Revision Transmittal Sheet

This sheet transmits Revision 1 of Service Bulletin SB-328-28-553 titled:
Fuel - Change of fuel lines within LH/RH feeder tank.

Model: Dornier 328-100

Title: Fuel - Change of fuel lines within LH/RH feeder tank

Figure 2: Pre-mod feeder tank distribution (Pre-SB-328-28-490)

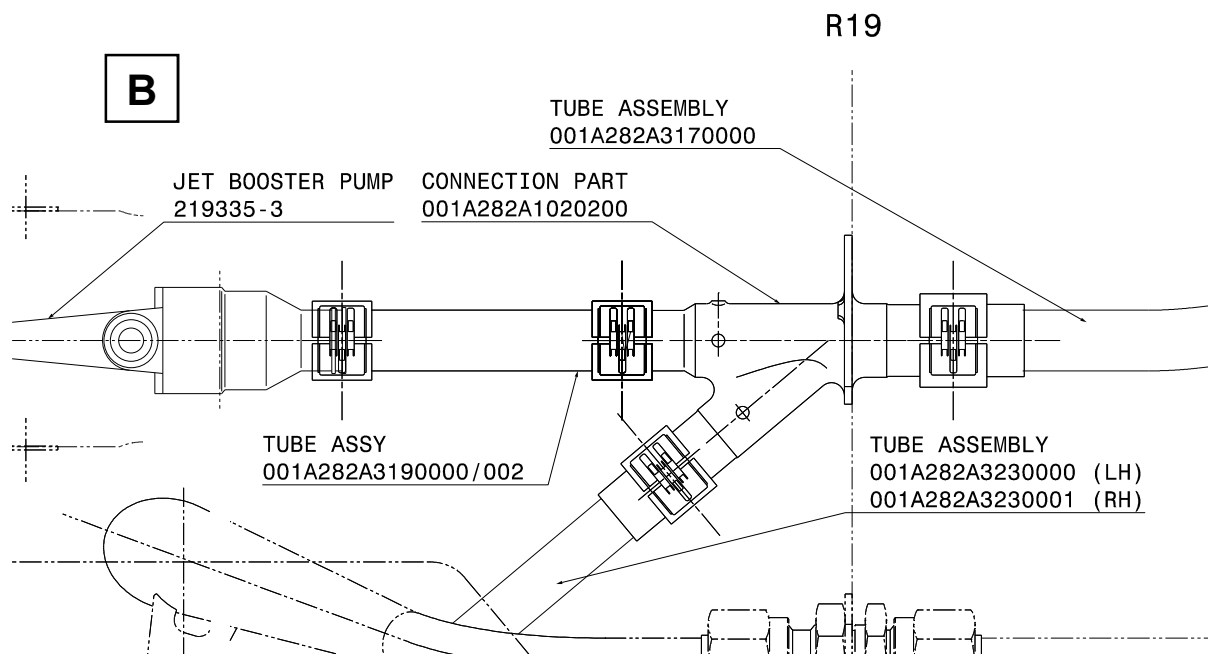
- 1) Make the aircraft safe for maintenance, refer to AMM JIC 00-30-01.
- 2) Defuel the aircraft, refer to AMM JIC 12-11-40-650.
- 3) Open/remove all doors, covers, panels, and removable fairings as necessary to get access to the modification area, refer to AMM JIC 06-40-02-020.
- 4) Remove the fuel jet pump. Refer to AMM JIC 28-21-04-020.
- 5) Remove tube assembly P/N 001A282A3190000.
- 6) Remove tube assembly P/N 001A282A3235000 (LH) & P/N 001A282A3235001 RH). Refer to AMM JIC 28-21-06.

Figure 3: Pre-mod feeder tank distribution (Post-SB-328-28-490)

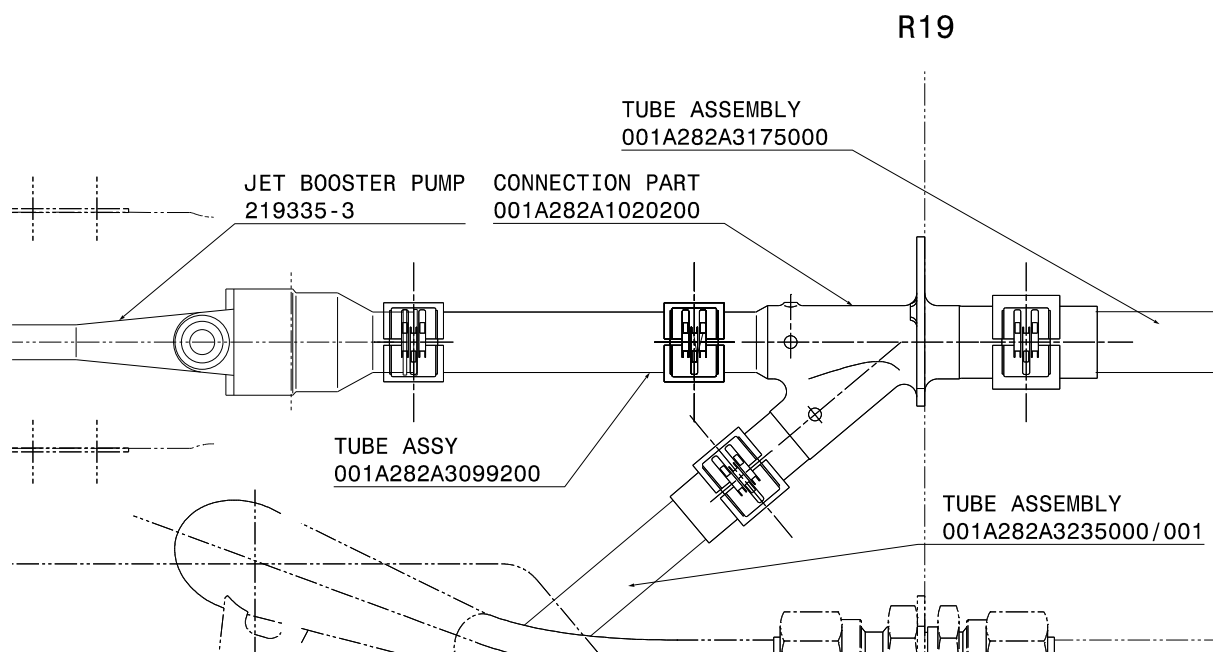
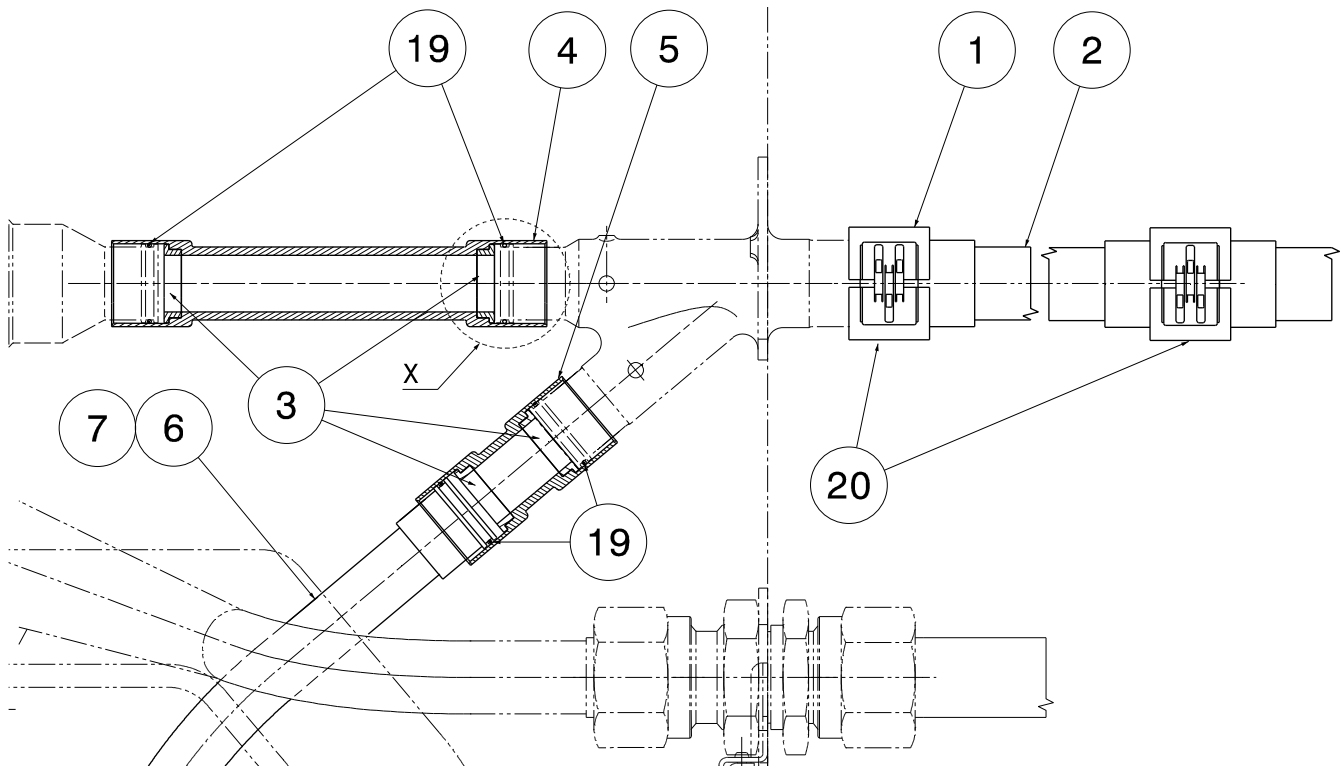
- 7) Remove clamp P/N 14C02-12A and clamp P/N W991-12DE from tube assembly P/N 001A282A7150000.
- 8) Remove tube assembly P/N 001A282A7150000.

Figure 4: Feeder tank distribution (post-mod)

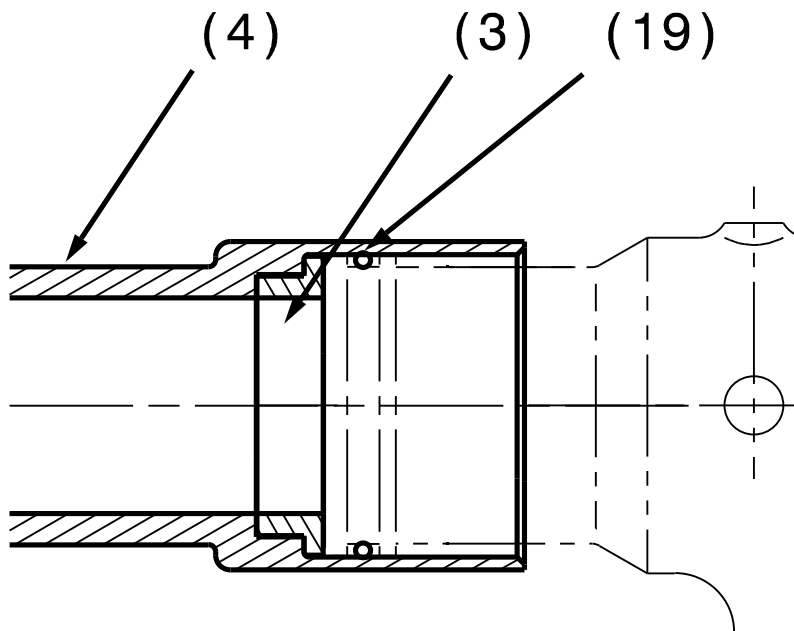
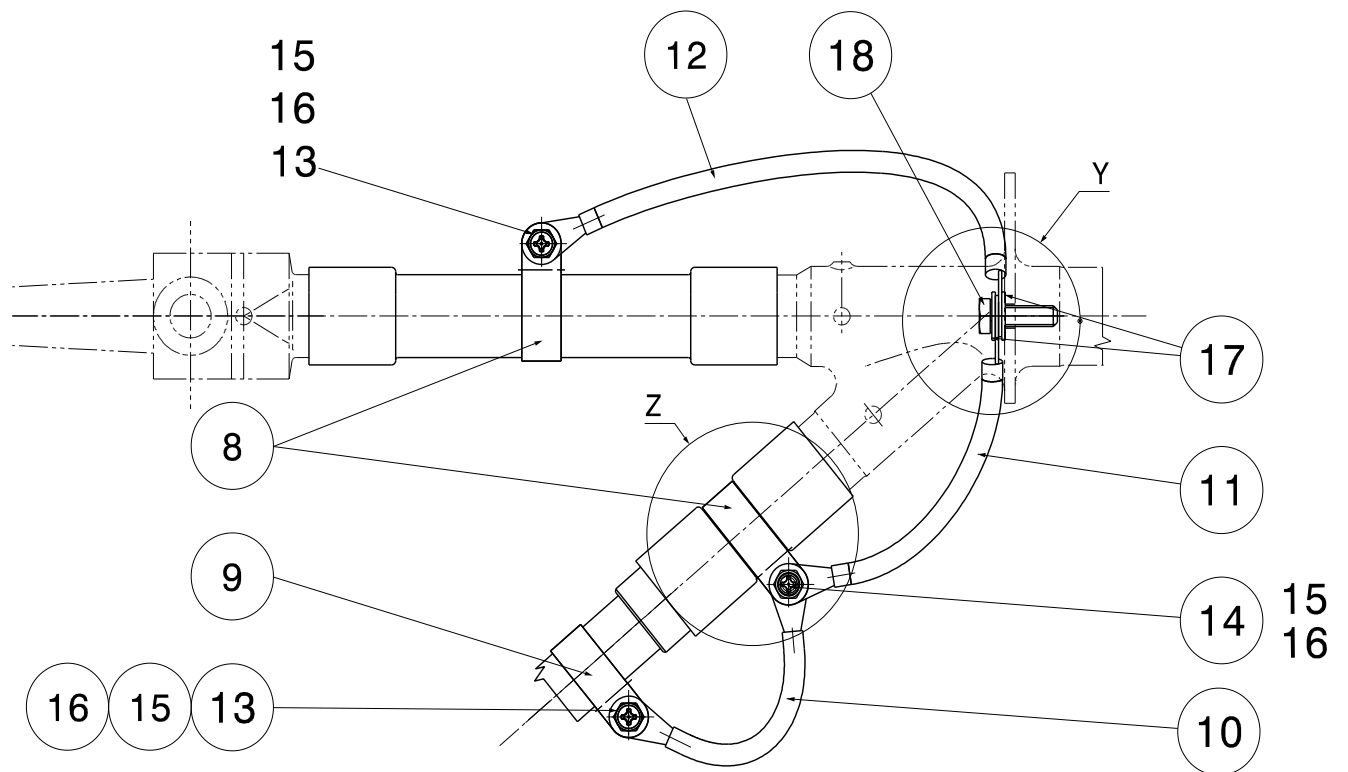
To prevent chafing of the fuel jet pumps, clamps and adjacent fuel lines in the feeder tanks new designed fuel tubes are provided by this Service Bulletin. The electrical bonding of the parts is realized by bonding straps and loop type bonding clamps. The adjacent engine feed line in the outer tank is set back to the initial type design. Accomplishment of this SB is considered as terminating action to EASA AD No. 2017-0016.

- 1) Install tube assembly (item 2) and attach with clamps (item 1).

- 2) On the workbench: Assemble clamps (item 8, 9) and grounding straps (item 10 - 12) to tubes (item 4, 5) and tube assembly (item 6, 7) with attachment material (item 13, 15, 16).
- 3) Insert spacer (item 3) to tube assembly (item 4) and install to connection part P/N 001A282A1020200.
- 4) Install fuel jet pump. Refer to AMM JIC 28-21-04-420-801.
- 5) Insert spacer (item 3) to tube assembly (item 5) and install to tube assembly (item 6 (LH)) / (item 7 (RH)).
- 6) Adjust clamps (item 8, 9) and grounding straps (item 10 - 12) and attach with attachment material (item 13 - 18). Refer to AMM JIC 20-28-00-910.

Figure 6: Feeder tank (post-mod)

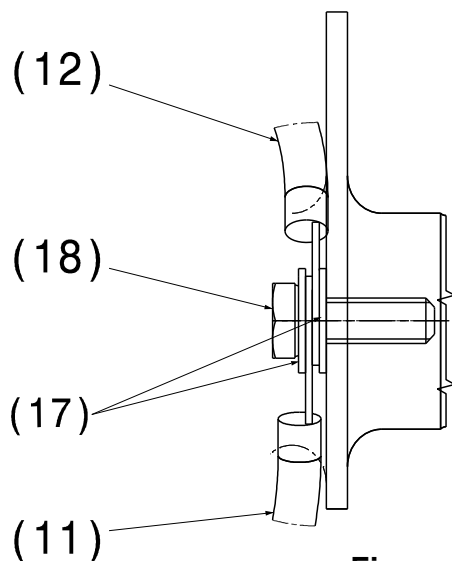
CAUTION: Make sure that the grounding straps have no contact to adjacent structure or other parts of the fuel distribution system!
Refer to Figure 6.
